UNITED STATES PATENT AND TRADEMARK OFFICE

APPLICATION NO.	FILING DATE	FIRST NAMED INVENTOR	ATTORNEY DOCKET NO.	CONFIRMATION NO.
09/876,396	06/07/2001	Syuichi Kariyazaki	14701	7345
23389	7590	10/29/2009	EXAMINER	
SCULLY SCOTT MURPHY & PRESSER, PC			MATTHEWS, COLLEEN ANN	
400 GARDEN CITY PLAZA			ART UNIT	PAPER NUMBER
SUITE 300			2811	
GARDEN CITY, NY 11530			MAIL DATE	DELIVERY MODE
			10/29/2009	PAPER

Office Action Summary	Application No. 09/876,396	Applicant(s) KARIYAZAKI, SYUUCHI
	Examiner Colleen A. Matthews	Art Unit 2811

DETAILED ACTION

Annotated Figure 14

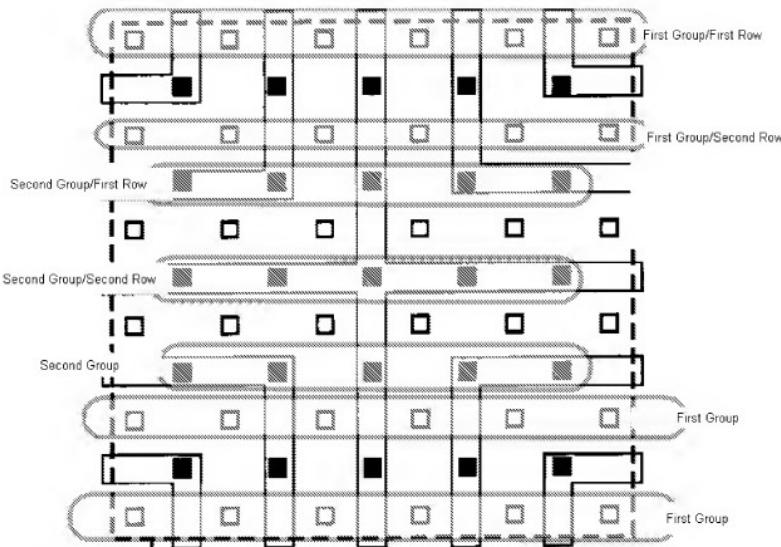
the interconnect pads forming a plurality of I/O cells including signal terminals, a portion of the I/O cells forming a first group (see Fig 14, "+Shape (plus)", for example- first group considered as the white squares corresponding to ground pads) of I/O cells and another portion of the I/O cells forming a second group (see Fig 14 " +Shape (plus)", for example- first group considered as the black squares corresponding to power pads) of I/O cells on an inner position of the mounting member with respect to the first group of I/O cells, the first group of I/O cells including a plurality of rows of

interconnect pads (see Fig 14, for example) disposed to encircle a center of the mounting member, and the second group of I/O cells including a plurality of rows of interconnect pads (see Fig 14 for example) disposed to encircle a center of the mounting member (also col 11 lies 48—col 12 line 40), the first and second groups of I/O cells being disposed directly under the semiconductor member (see Fig 2)

the first group of I/O cells arranged in a first row and a second row (see annotated Fig 14 below, "First group/First row" and "First group/Second row", for example) disposed on an inner position relative to the first row

the second group of I/O cells arranged in a first row and a second row (see annotated Fig 14 below, "Second group/First row" and "Second group/Second row", for example) disposed on an inner position relative to the first row;

Regarding claim 10, Moresco discloses a semiconductor device, wherein at least one of the first group (see Fig 14- first group considered as the white squares corresponding to ground pads) and the second group (see Fig 14- first group

considered as the black squares corresponding to power pads) includes an outer group (see Fig 14- first group considered as the white squares corresponding to ground pads) and inner group (see Fig 14- first group considered as the black squares corresponding to power pads) disposed on the inner position of the mounting member with respect to the outer group (see Fig. 14, the center black square/power pad is disposed in an inner group).
